EXHIBIT C

Summary of Comments on Proposed Carbon PipeLine Map 1-16-2025.pdf

Page: 1

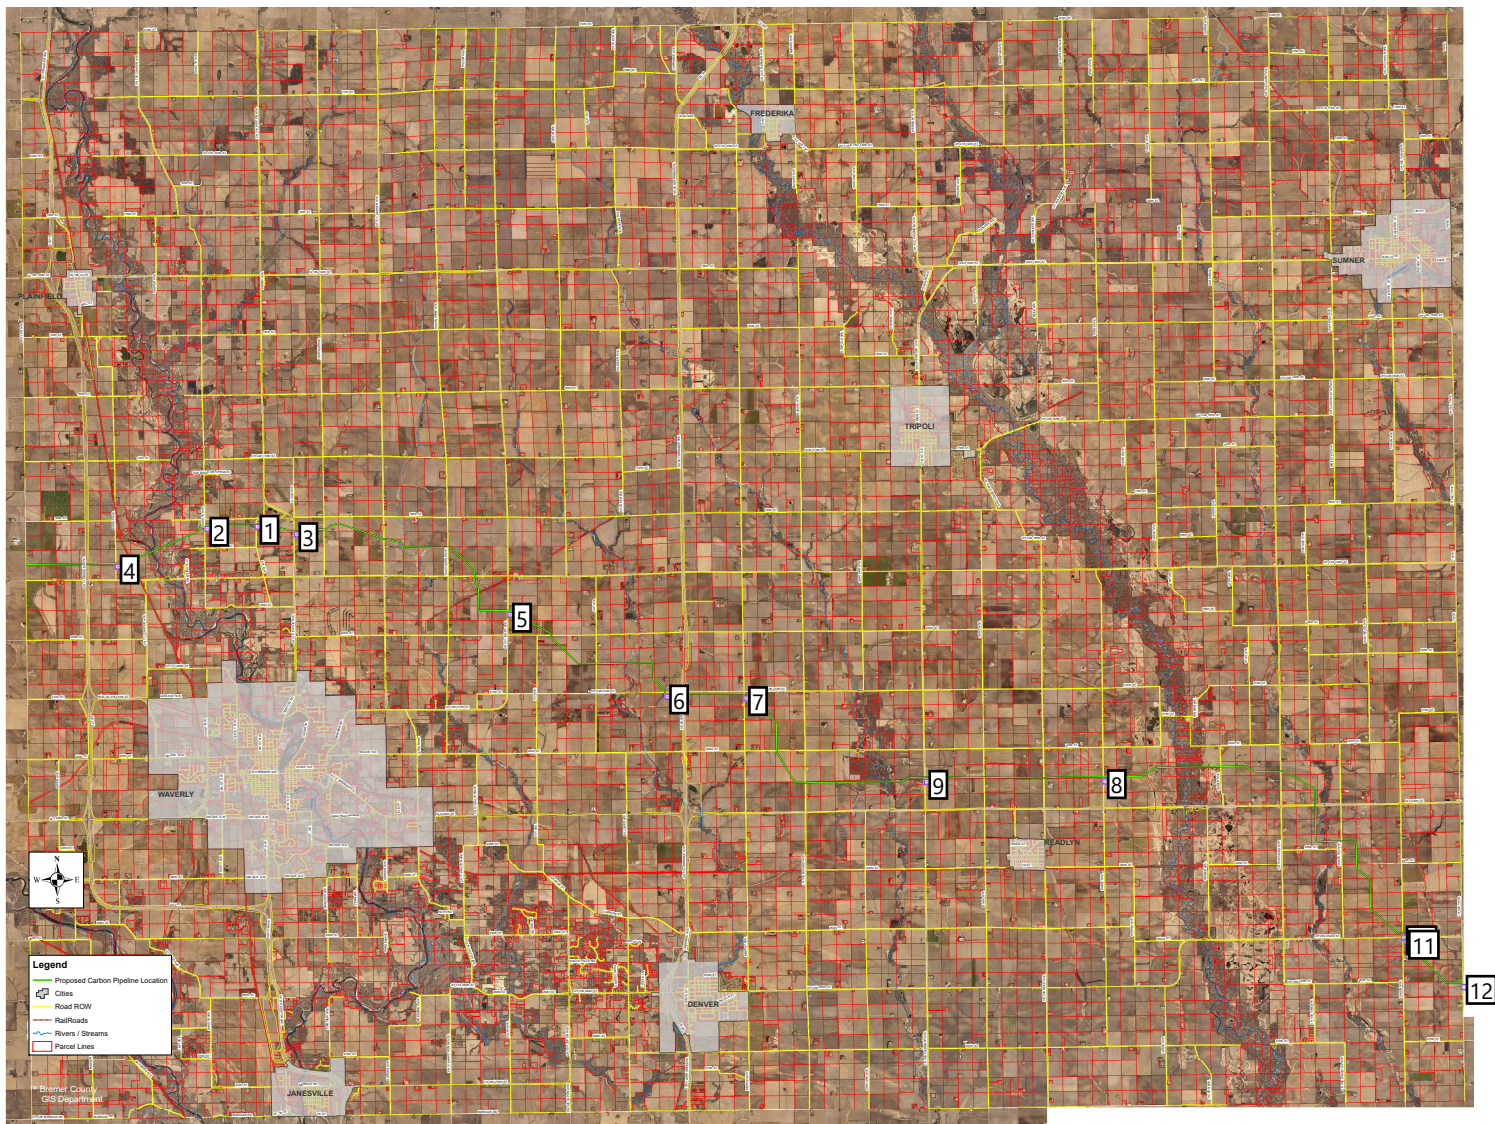
Number: 1	Author: Imoore	Subject: Sticky Note	Date: 1/17/2025 9:17:36 AM
	Less than 495 feet from county road intersection			
	Number: 2	Author: Imoore	Subject: Sticky Note	Date: 1/17/2025 9:17:16 AM
	Less than 495 feet from county road intersection			
	Number: 3	Author: Imoore	Subject: Sticky Note	Date: 1/17/2025 9:20:48 AM
	Likely less than 250 feet from culvert 1313-A			
	Number: 4	Author: Imoore	Subject: Sticky Note	Date: 1/17/2025 9:14:07 AM
	Less than 250 feet from county culvert crossing			
	Number: 5	Author: Imoore	Subject: Sticky Note	Date: 1/17/2025 9:25:20 AM
	Likely less than 250 feet from 1384			
	Number: 6	Author: Imoore	Subject: Sticky Note	Date: 1/17/2025 9:27:24 AM
	Less than 250 feet from culvert 1584			
	Number: 7	Author: Imoore	Subject: Sticky Note	Date: 1/17/2025 9:27:47 AM
	Less than 495 feet from county intersection			
	Number: 8	Author: Imoore	Subject: Sticky Note	Date: 1/17/2025 9:36:10 AM

Less than 250 feet from county culvert 1829 and 1829-A			
	Number: 9	Author: Imoore	Subject: Sticky Note	Date: 1/17/2025 9:30:04 AM
	Verify if this is more than 495 feet from private ingress egress to 2252 Piedmont			
	Number: 10	Author: Imoore	Subject: Sticky Note	Date: 1/17/2025 9:38:59 AM
	Less than 495 feet from county road intersection			
	Number: 11	Author: Imoore	Subject: Sticky Note	Date: 1/17/2025 9:39:09 AM
	Less than 495 feet from county road intersection			
	Number: 12	Author: Imoore	Subject: Sticky Note	Date: 1/17/2025 9:40:15 AM
	Less than 495 feet from private ingress/egress
